Dear Thanh-Tuan Tran and Referee #2,

Reply to comments received on 02 Feb 2023 from Thanh-Tuan Tran

Reply to comments received on 07 Feb 2023 from Referee #2

Figure 3. Main jacket dimensions (a) and coordinate system (b)

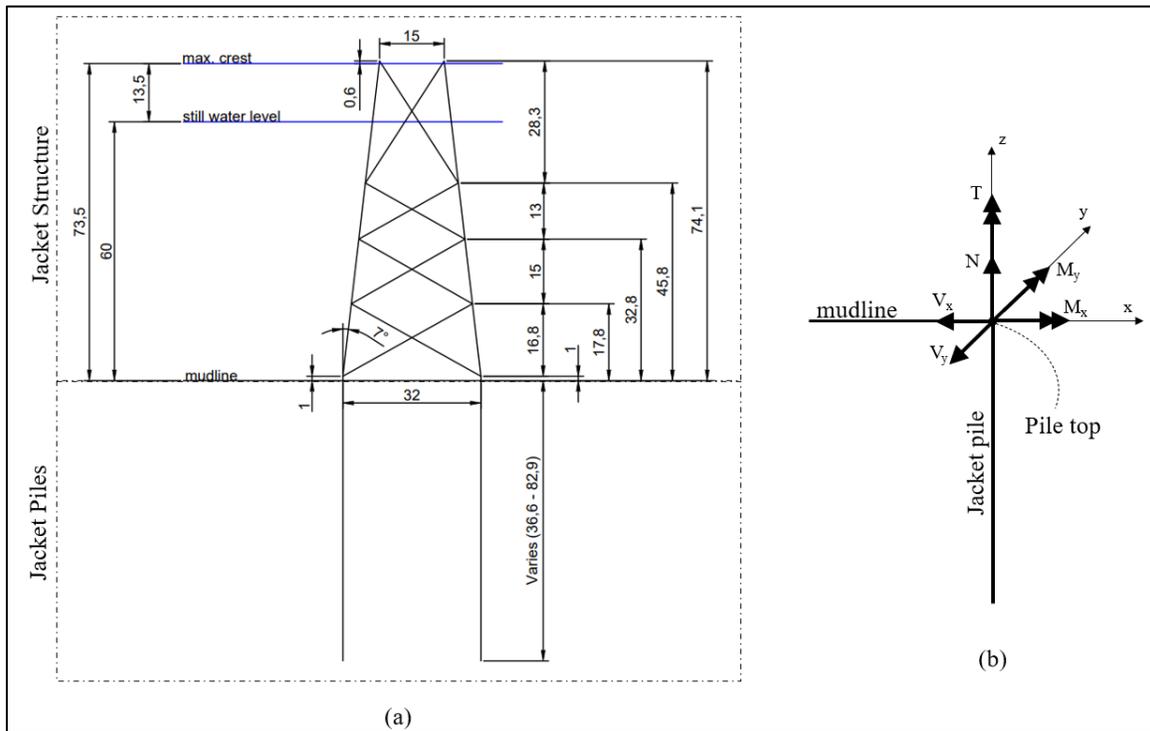
#3: The coordinate system of the model must be illustrated. Currently it is very hard to work out the applied moment and force loads. Where are the loads exactly applied.

Reply: Figure 3 is replaced with an updated image showing the coordinate system (a copy of the figure is also provided below for your convenience). Loads reported in the article are pile top loads of the jacket

piles. Internal loads of the jacket structure are not reported. We also try to make the distinction between the jacket structure and the jacket piles clearer in the update to Figure 3.

In the OpenFAST simulations, the environmental loads are applied to the global model and the resulting pile top loads are calculated by the software. In the OpenSeesPL simulations, ref. Figure 4, the pile top loads are applied at the pile top (i.e., mudline).

Revision to article: Figure 3 is replaced with the follow image and changes to the associated caption are highlighted in yellow:

Figure 6. Maximum seed-averaged pile-top tension (orientations relative to wave direction)

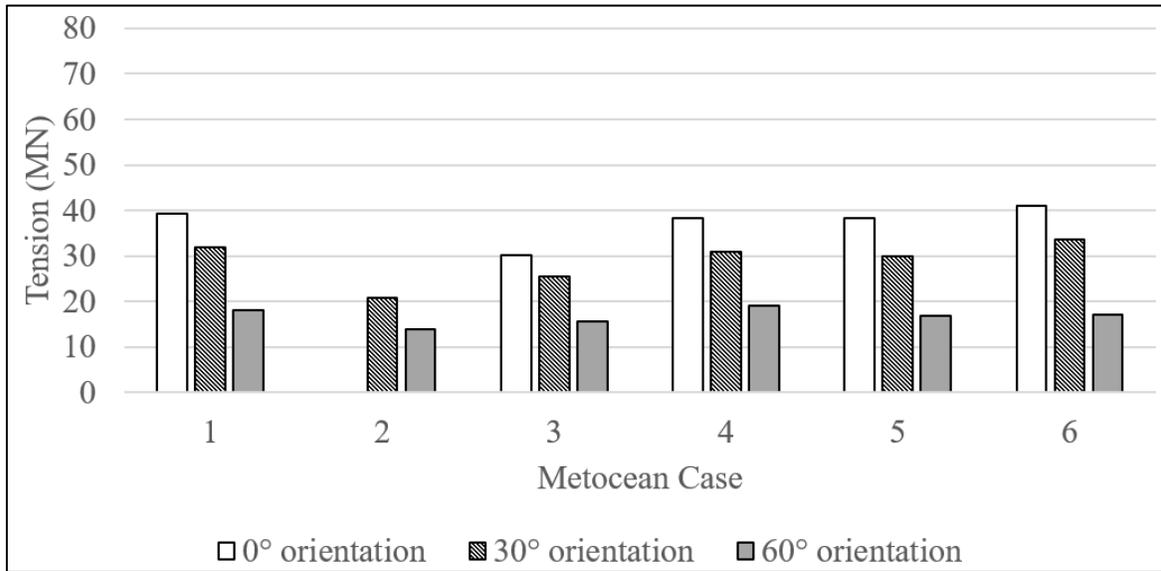
#4: The results from parametric studies (Tables 8-9) should be graphical reported. The polar diagram, which shows how the response polarized under the metocean condition, is recommended

Reply: The results previously reported in Tables 8 and 9 are now represented graphically in the update to the article (reproduced below for your convenience). Please note that these results cannot be shown in a polar diagram, since they are axial compression and tension loads acting along the same axis (z-

Revision to article: Table 8 is replaced with the following figure and associated caption:

Figures 6 and 7 show the resulting maximum pile top tension and compression forces, respectively, for the three jacket orientations. These are maximum values averaged over the six wind and wave seeds; the appropriate load factor per DLC is also included. The orientations are provided relative to wave direction, the reason for this is further explained in the following subsection. Metocean case 2 did not include a 0° orientation relative to wave direction, as cases 2 and 3 were simulated considering the jacket orientation relative to the wind direction.

Figure 10. Maximum pile top loads per jacket orientation (relative to the wave direction) for two current speeds

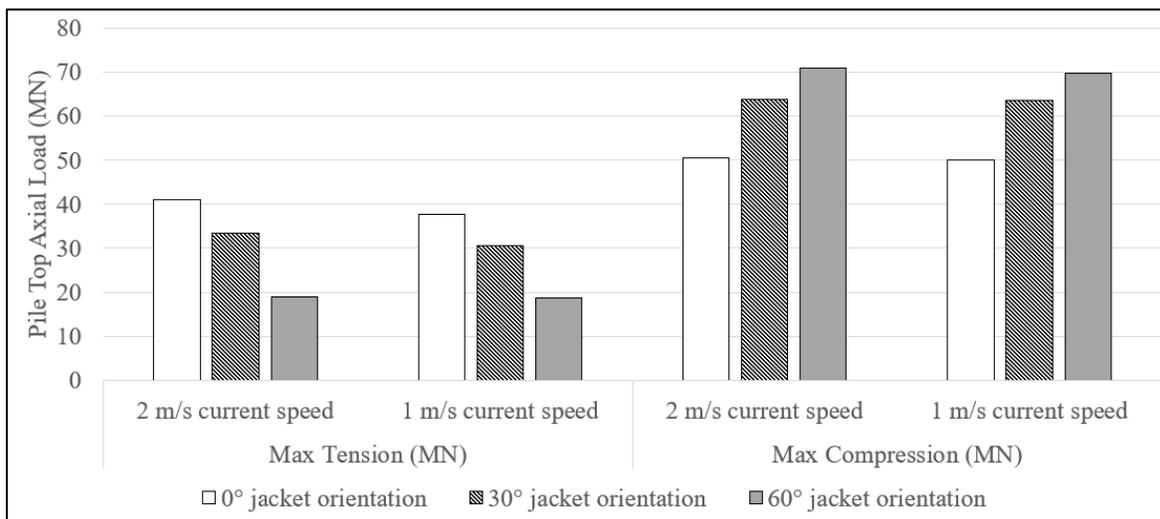
#2: A brief discussion on the relative impact on the current loads to the overall total system loading should be included. The 2 m/s current load in line with the waves may overshadow the effect of the the wind loading on the structure. The likelihood of such an extreme current occurring simultaneously with the 50-yr wind and 50-yr wave for a given directional bin has a real recurrence interval of much larger than 50-yrs, and is likely overly conservative. The reviewer suggests running a sensitivity study of at least one additional current speed, 1 m/s for example, to determine whether the trends in wave directionality controlling optimum platform orientation hold constant.

Reply: We appreciate this suggestion and decided to rerun the simulations considering a current speed of 1 m/s, as suggested. The findings from these additional simulations are incorporated in the revised article under a new section.

In order to investigate whether the conservative current speed (2 m/s) might have influenced the findings, the simulations were rerun considering a reduced current speed of 1 m/s. As is to be expected, the pile top axial loads were overall reduced due to this change. Nevertheless, the trend elaborated in section 5.1, which demonstrates that the jacket orientation should be set relative to the wave direction, for the reference site conditions, remains valid for the reduced current speed (Figure 10). This figure also demonstrates that the axial pile top loads are not particularly sensitive to reasonable variations in the current speed.

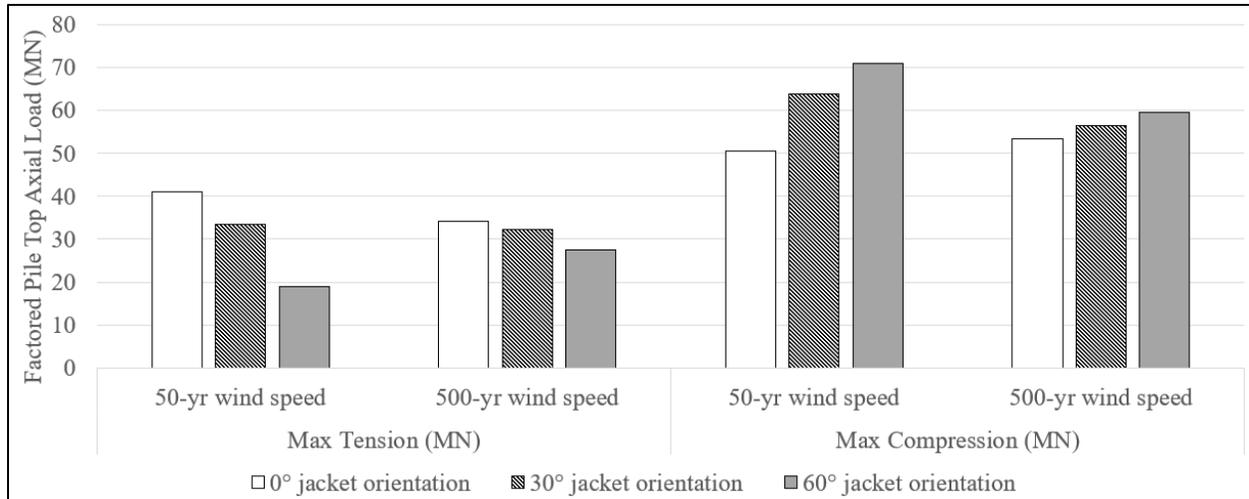
#3: A consideration of DLC 1.6, where the turbine is operational with conditional 50-yr waves is considered in a full jacket design, and may be found to control the maximum member forces in certain members, especially near the top of the structure. At a minimum the wave conditions for DLC 1.6 near the rated turbine wind speed should be presented, along with a comparison of the turbine thrust loads at rated vs. idling with and without yaw error. With those data inference may be made as to whether DLC 1.6 might control for certain members and orientations.

Reply: Additional simulations were performed to determine the pile top axial loads for DLC 1.6. The omni-directional conditional 50-year wave ($H_{s,SSS}$) was determined to be 9.5m. Buoy data entries with wind speeds above the turbine cut-out wind speed, after adjustment for the height difference, were filtered out and the Gringorten method was applied on the remaining dataset to determine this value. OpenFAST simulations were then run conservatively combining this conditional 50 year wave with the turbine’s rated wind speed (10.59 m/s). Wind-wave misalignments of 0°, 30°, 60°, and 120° and jacket

orientations of 0°, 30°, and 60° were considered. A partial safety factor of 1.35 was applied and the results were seed averaged over six wind and wave seeds. The resulting pile top loads for DLC 1.6 and a comparison with the results presented in the article (DLCs 6.1 and 6.2) is provided in the figure below:

As can be seen in the figure, the pile top axial loads under DLCs 6.1 and 6.2 are higher than the loads for DLC 1.6 in all the considered cases. These findings support the statement made in the article under section 4.1: “These DLCs [6.1 and 6.2] were selected as the most likely governing load cases for the jacket pile embedment depth.” Therefore, no changes are introduced in the article as a result of these simulations. Nevertheless, we hope this adequately addresses your comment.
